# Environmental Impact Assessment Report Addendum– Tesco Cavan Town

Prepared by RMLA Limited

On behalf of Tesco Ireland Limited

July 2023

**Figure 4.1 Amended Proposed Site Layout Plan**

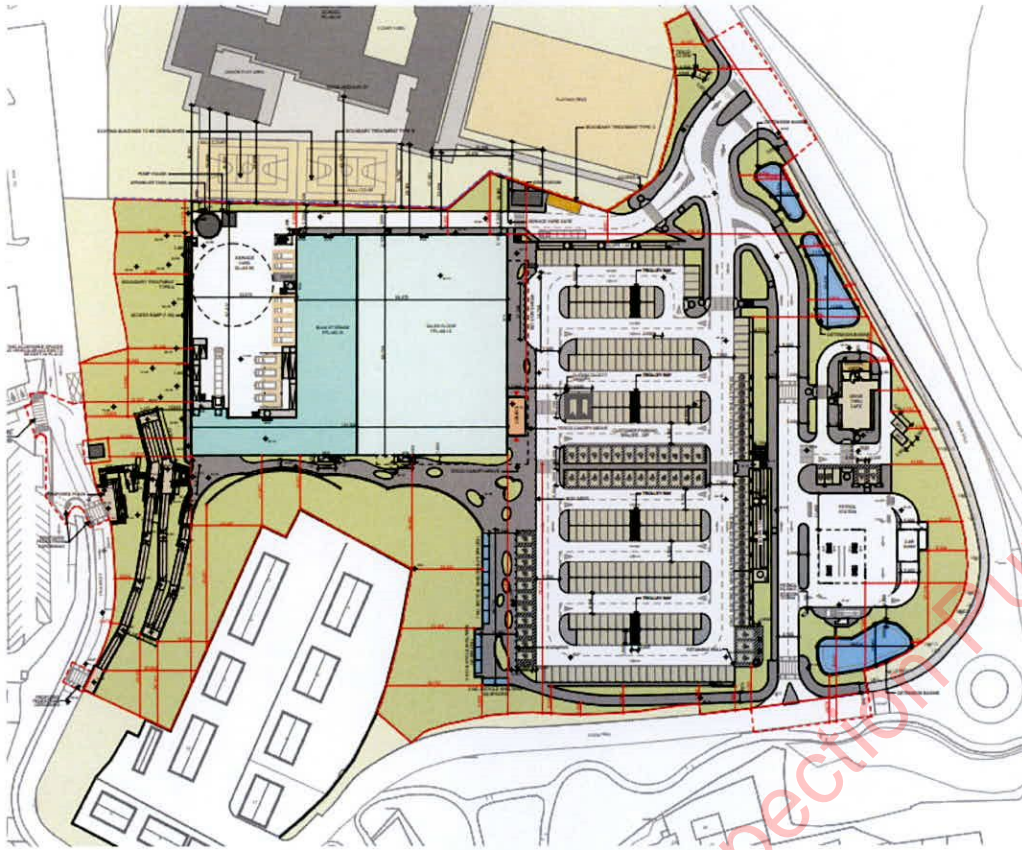
As a result of the RFI, a number of amendments have been undertaken to the proposed site layout (refer to Figure 4.1), which constitutes an alternative layout to that originally submitted with the planning application. In summary, the amendments to the proposed site layout include, inter alia:

3. The design of the walkways and public realm between Cavan Town Centre and the proposed development are revised to provide greater levels of amenity for users.

4. The potential for a bus route to serve the proposed development is established.
5. Alterations to boundary treatments to the west and northern boundaries to include a mix of vertical louvre screening, paladin fencing, and timber fencing.

6. Relocation of the pump house and sprinkler system from the area adjacent to the ESB sub station, to the northwestern corner of the service yard.

Figure 6.1 Indicate Traffic Layout of proposed development

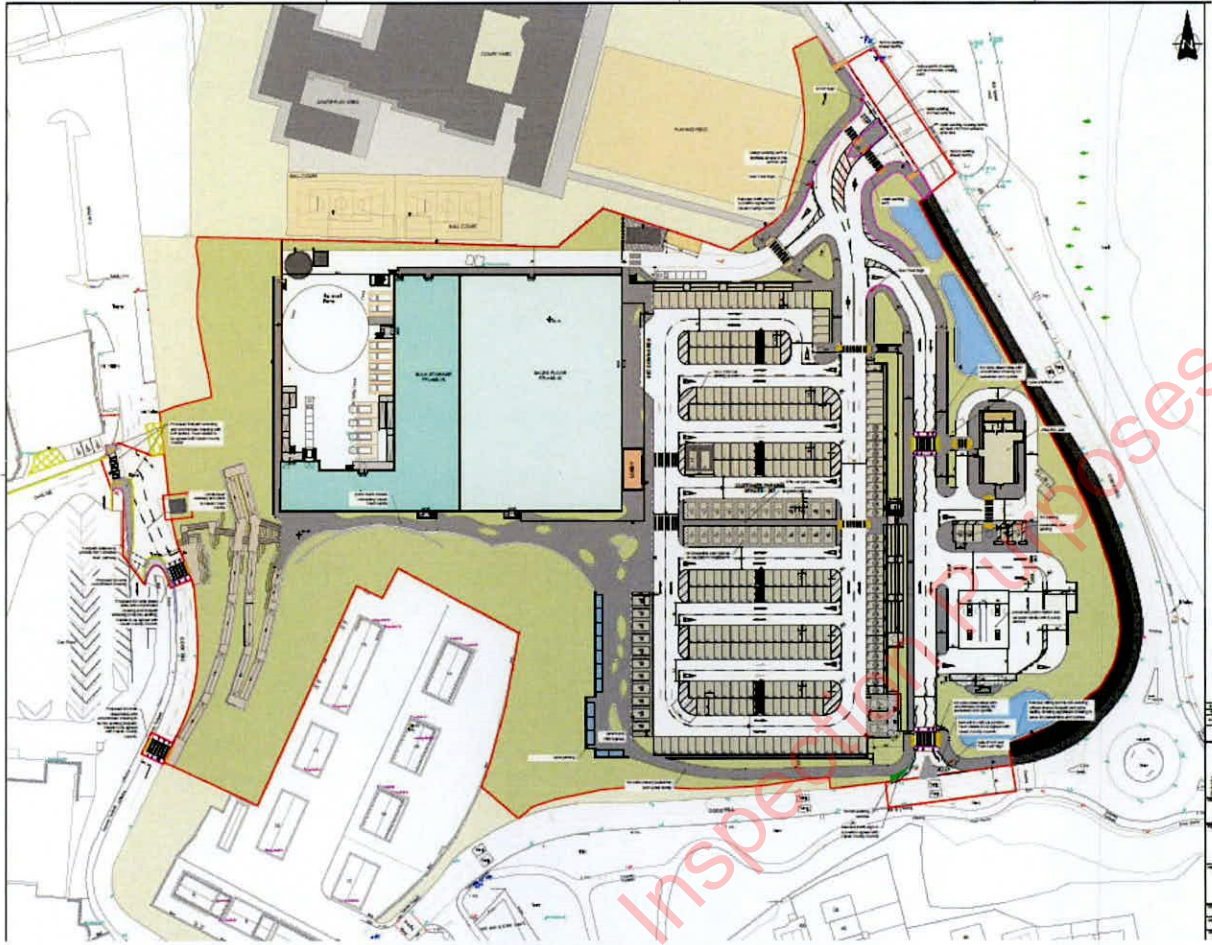
In response to the Request for Further Information, amendments have been made to the traffic and transport design layout of the proposed development. The indicative traffic and transport layout of the proposed development is presented in Figure 6.1.

The main access junction is redesigned, reallocating road space in favour of active travel modes:

The design of the walkways and public realm between Cavan Town Centre and the proposed development are revised to provide greater levels of amenity for users.
